RS-05-039

Clinton Power Station
Facility Operating License No. NPF-62
NRC Docket No. 50-461

Subject: Response to Request for Additional Information for License Amendment
Related to Revision of Instrument Channel Trip Setpoint Allowable Values

ATTACHMENT 1
Response to Request for Additional Information

Table 3.3.6.1-1 (page 1 of 6)
Primary Containment and Drywell Isolation Instrumentation

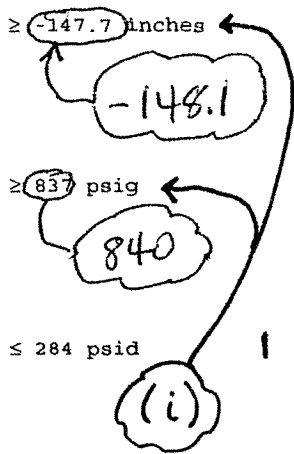
1. Main Steam Line Isolation					
a. Reactor Vessel Water Level-Low Low Low, Level 1	1,2,3	4	G	SR 3.3.6.1.1 SR 3.3.6.1.2 SR 3.3.6.1.3 SR 3.3.6.1.5 SR 3.3.6.1.6 SR 3.3.6.1.7	≥ -147.7 inches

b. Main Steam Line Pressure-Low	1	4	H	SR 3.3.6.1.1 SR 3.3.6.1.2 SR 3.3.6.1.3 SR 3.3.6.1.5 SR 3.3.6.1.6 SR 3.3.6.1.7	≥ 837 psig
c. Main Steam Line Flow-High	1,2,3	4	G	SR 3.3.6.1.1 SR 3.3.6.1.2 SR 3.3.6.1.3 SR 3.3.6.1.5 SR 3.3.6.1.6 SR 3.3.6.1.7	≤ 284 psid

(i) INSERT

This Function is OPERABLE with an actual Trip Setpoint value found outside its calibration tolerance band provided the Trip Setpoint value is conservative with respect to its associated Allowable Value and the channel is re-adjusted to within the established setting tolerance band of the Nominal Trip Setpoint.
